Flight Procedures Cover Page	Task Action: FLIGHT CHECK	Task Type: IAP	Estimated Chart Date: 10/29/2026	APWS Task ID: 916ACC7409D74DDAA3A936D19501266D	APWS Project ID: 65E404BDC4D046C98B395AC24A47F4E3
Procedure: RNAV (GPS) RWY 7 AMDT 1		Enroute: NO	Specialist: Kercher, Devon		Agreement Number:
Airport ID: KLEB			Airport City: LEBANON		State: NH
Facility ID:	Facility Type:	Flight Inspection Remark Type: New FC Slot			
Procedure Comments: Approval letter request to publish a Vertical Descent Angle (VDA) (of a procedure where the FAC is straight-in aligned) that is less than the angle of a VGSI installed to the same runway. PENDING DATA USED FOR KLEB AIRPORT. CONTACT ROBERT HAMILTON (AJV-A431) 405-954-4608. QUALITY 29 CHECKED QUALITY 37 CHECKED

Approval Request: Lebanon Muni, MA, Lebanon, NH (KLEB) RNAV (GPS) RWY 07

RNAV (GPS) RWY 7

LEBANON MUNI (KLEB)

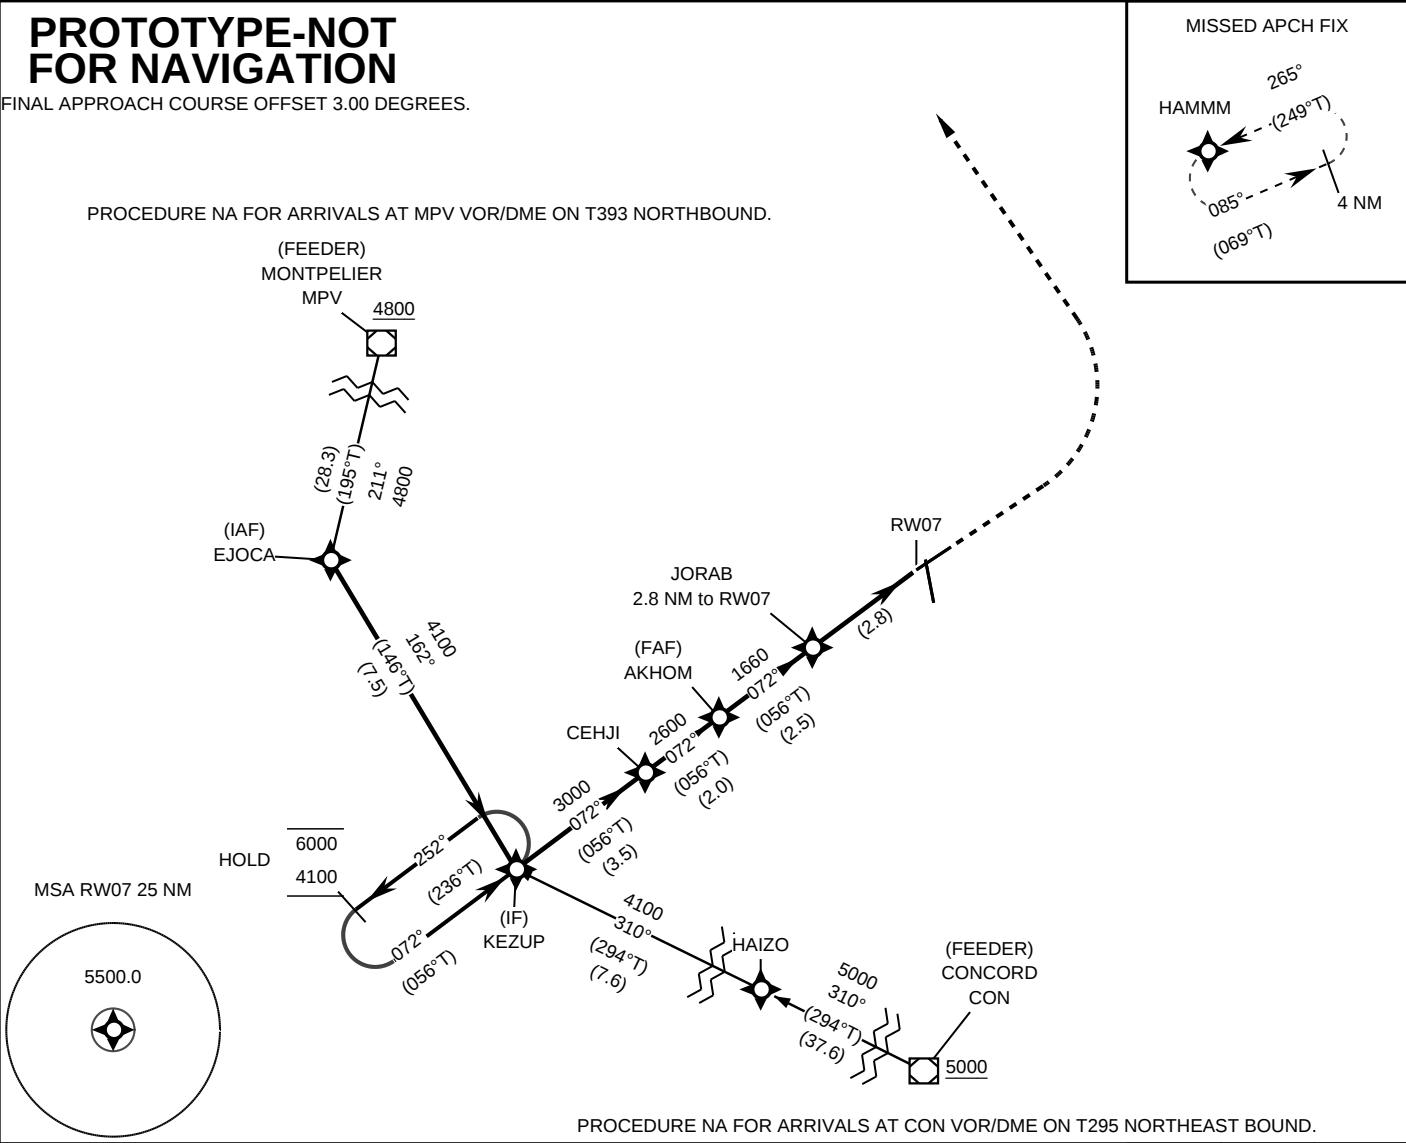
There isn't a current AFS Approval Letter for VDA that is less than the angle of a VGSI installed to the same RWY, though here is my standard Approval Request write-up. Please forward one for approval:

Request approval to publish a Vertical Descent Angle (VDA) (of a procedure where the FAC is straight-in aligned) that is less than the angle of a VGSI installed to the same runway.

- 1. Current Configuration:** The commissioned VGSI angle/TCH for RWY 07 is currently set at 4.00°/50.7 (51). The procedure amendment's proposed VDA is 3.50°/50.0.

- 2. Documentation:** The currently published chart note will continue to be published stating: "VGSI AND DESCENT ANGLES NOT COINCIDENT (VGSI ANGLE 4.00°/TCH 51.0)".

- This restriction and NOTAM will remain in effect until the VGSI (4.00°/TCH 51) is realigned and flight inspected to match the published RNAV descent angle (3.50°/TCH 50) which is necessary for altitude and track constraints around KBOS.
